RE: Amendment request for License Number 25-01706-03, Docket No. 030-00872

From: Browder, Rachel
Sent: Wednesday, December 09, 2009 11:40 AM
To: 'Dan Corti'
Subject: Request for Additional Information
Attachments: Information that should be Submitted for Decommissioning Surveys.doc

INFORMATION THAT SHOULD BE SUBMITTED
TO THE NRC STAFF FOR DECOMMISSIONING
OF LICENSED FACILITIES

Site Plan & Hot Zones:
Room 3262

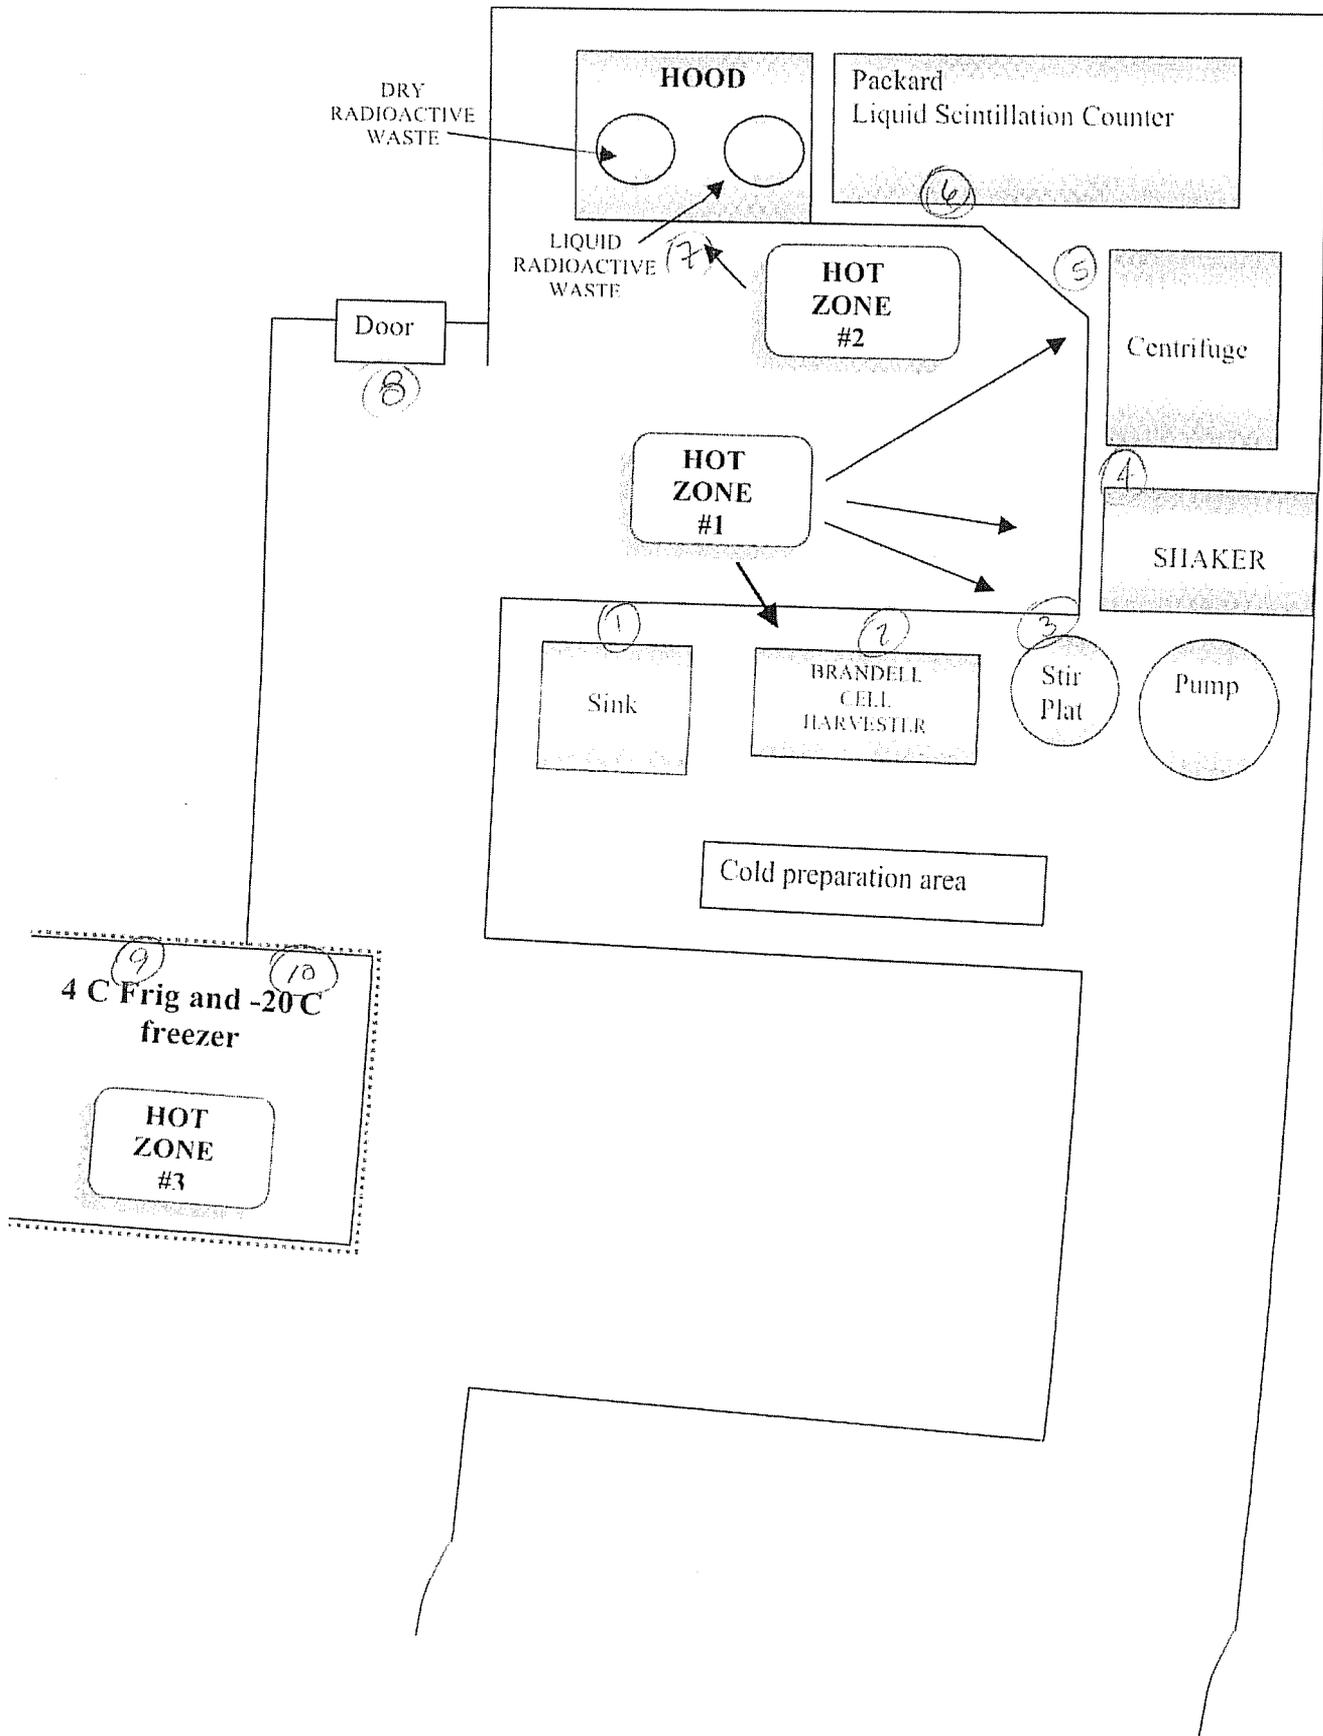
- 7) Maps and/or drawings which clearly indicate the locations where wipes and fixed measurements were taken. If contaminated drain lines (or other buried and inaccessible pipes) are an issue, blueprints or drawings should be included that show the locations of the drain lines, including where they originate and end.

- 7) Maps and/or drawings which clearly indicate the locations where wipes and fixed measurements were taken. If contaminated drain lines (or other buried and inaccessible pipes) are an issue, blueprints or drawings should be included that show the locations of the drain lines, including where they originate and end. Please see attached survey map.
